# SERVICE INFORMATION LETTER

SIL T-061  
Revision 2  
Page 1 of 11

- DATE: August 7, 2017
1. SUBJECT: Fuel Quantity Transmitter Upgrade
  2. MODEL: 480 and 480B
  3. EFFECTIVITY: Aircraft Equipped with Aerotech Fuel Cells  
(480/480B: S/N 5014-5197)
  4. REFERENCE: Enstrom TH-28/480 Series Illustrated Parts Catalog, Rev. 10 or Later Revision
  5. BACKGROUND:

*Figure 1. Wiring Cutting Location*

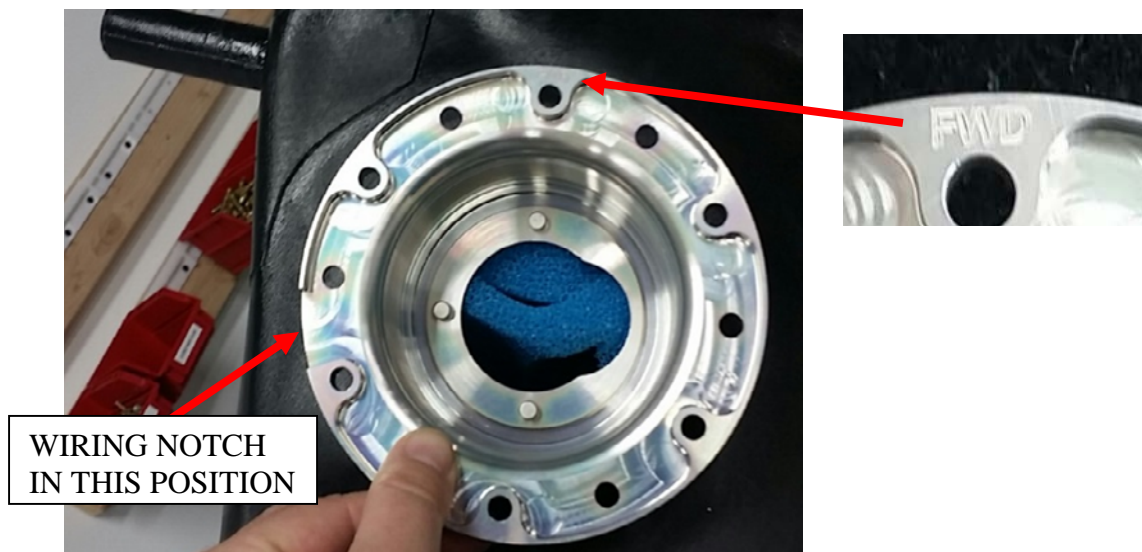
- 6.5 Remove the R/H fuel cell skin. (Refer to MM, Para. 8-14.)
- 6.6 Cut the old fuel quantity transmitter wiring harness plug. Remove hardware and discard. (See Figure 1.)

*Figure 3. Wiring Notch Location*

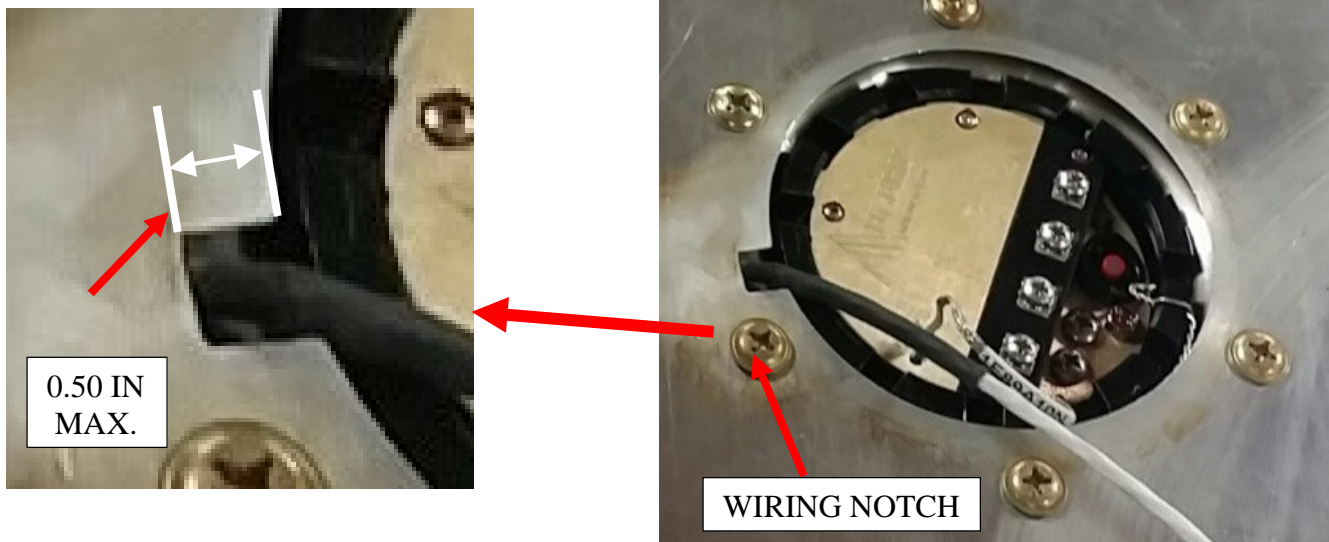
- A. Attach the fuel quantity transmitter cover to the skin using the three existing mounting holes.
- B. Drill the three additional 0.281 in/7.1 mm diameter holes in skin.
- C. Remove the cover and retain for step 6.19.M.
- D. Cut a 0.40 in/10.2 mm wide and 0.50 in/12.7 mm max. deep notch in the skin for wiring clearance (notch is to line up with the notch in the flange cup assembly (P/N 4122084-1). Radius the inside and outside corners of the notch. (Refer to Drawing No. 4230008, Sheet 4, Zone B-3, Detail C and also see Figure 3.)
